TENDER NO. IGL/ET2/CP/CP18529
SUPPLY OF DECOMPRESSION UNITS (DCU) 450 SCMH

Replies to Bidders' Queries - 1

PIPING & INSTRUMENT DIAGRAM FOR
(450 SCMH)

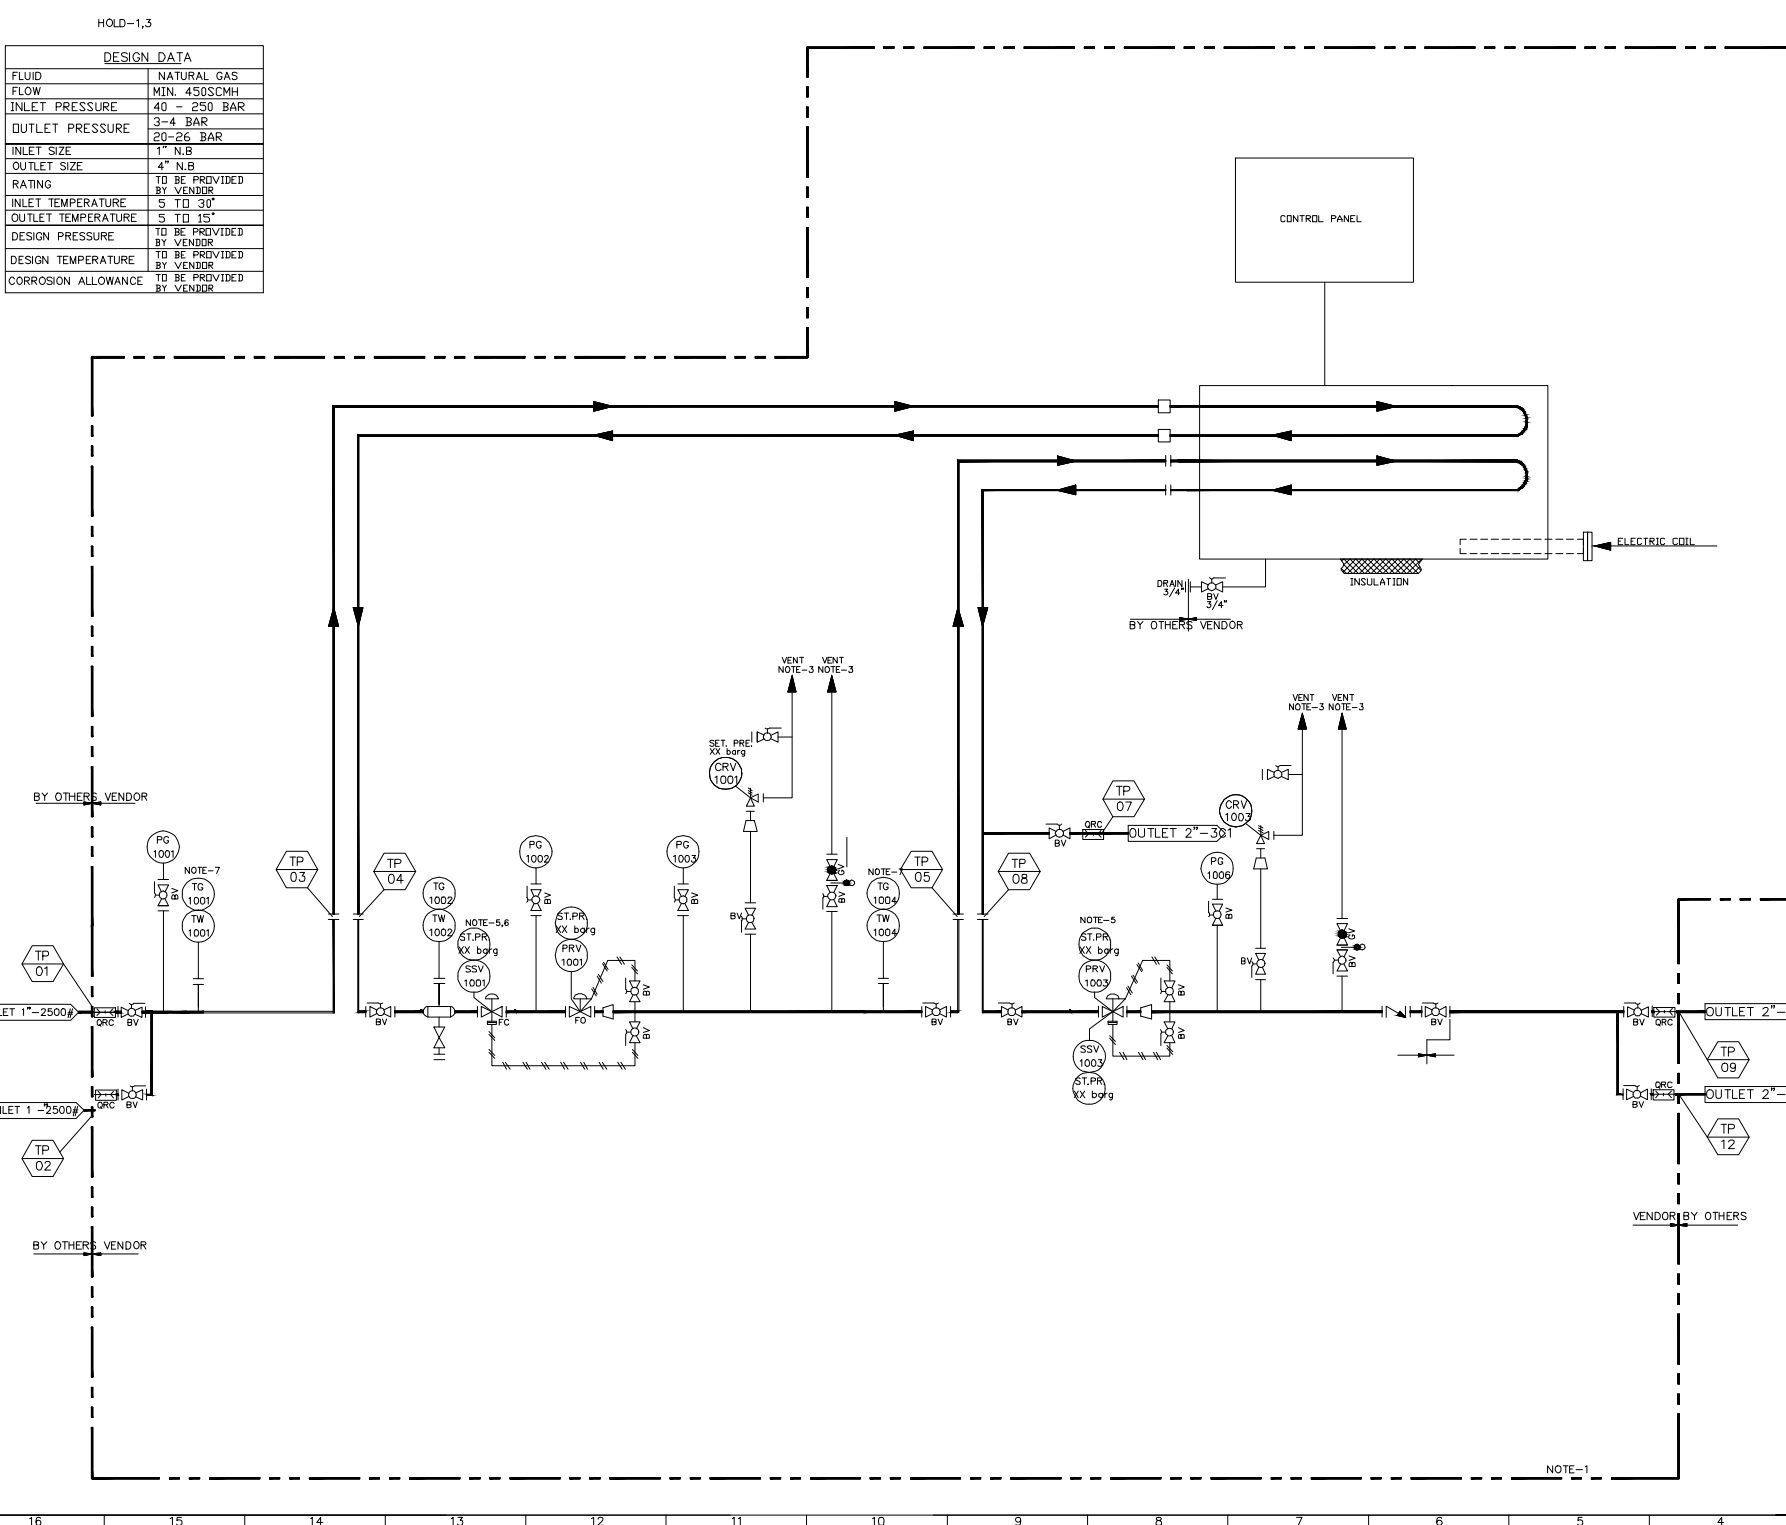
13	P & ID for 450 SCMH (19 OF 19)		For the inlet, 1" QRC is specified in the P&ID. However, 1/2" QRC size is suitable for the required flow rate. The bidder requests that the corporation accept the 1/2" size for the QRC at the inlet.	Tender conditions prevails. Please refer updated P&ID.
14	P & ID for 450 SCMH (19 OF 19)		The bidder needs to understand the purpose of providing the QRC at the outlet. Generally, PRS/DCU units are equipped with an isolation valve at the outlet.	Tender conditions prevails. Please refer updated P&ID.

Sr. No.	Clause/Page	Clause/Tender Condition	Bidder's Query	IGL's Reply
15	P & ID for 450 SCMH (19 OF 19)		Bidder need to understand that meaning of TP.	TP denotes Tapping Point.
16	Technical Specification; Cl. 6. TECHNICAL REQUIREMENTS; Page 8 of 19. Technical Specification; Cl. 7.2.4 SSV and Pressure Regulators; Page 12 of 19.	Inlet line size and outlet line sizes (for both outlets) should be considered taking velocity limitation to 30 m/s throughout the DCU. The Complete station shall be designed in such a way that the mean gas velocity remains within 20 m/s. Velocity in the piping upstream/downstream of Pressure Reduction Station shall be within 20 m/s.	Pl confirm velocity limitation to 20 or 30 m/s throughout the DCU.	The velocity limitation is being clarified as : The Complete DCU shall be designed in such a way that the mean gas velocity remains within 20 m/s. Velocity in the piping upstream/downstream of all regulators installed in DCU shall be within 20 m/s.

40	IGL/ET2/CP/CP18529 PART – II OF II TECHNICAL VOLUME P&ID (19 of 19)	P&ID the outlet of 20-26 Barg shown after 1st stage and 3-4 Barg outlet shown after 2nd stage.	We propose providing both outlet options after the second stage to ensure accurate and desired output. The two available options are as follows: 1.Two separate lines with two different regulator outputs. 2.A single regulator with an optional pilot, allowing adjustment according to your specific requirements. Please confirm.	Bidder seems to be requesting for regulation with following methodology 1) Regulation from CNG cascades to intermediate pressure 2) Regulation from intermediate pressure to outlet pressure of 20-26 bar 3) Regulation from intermediate pressure to outlet pressure of 3-4 bar Bidder's above request for introducing intermediate regulation to effect desired outlet pressure of 20-26 bar as well as outlet pressure of 3-4 bar may be accepted, provided it meets corresponding technical parameters of second stage regulators cited in technical document of the tender and the rest of the conditions like space limitations, safety parameters etc. are not compromised. Notwithstanding above, acceptance for P&ID offered by bidder is at IGL discretion and vendor shall be required to get the P&ID approved from IGL before commencing manufacturing of DCU. In case, P&ID offered by vendor is not accepted by IGL, then he may be advised to follow the P&ID provided in the tender.
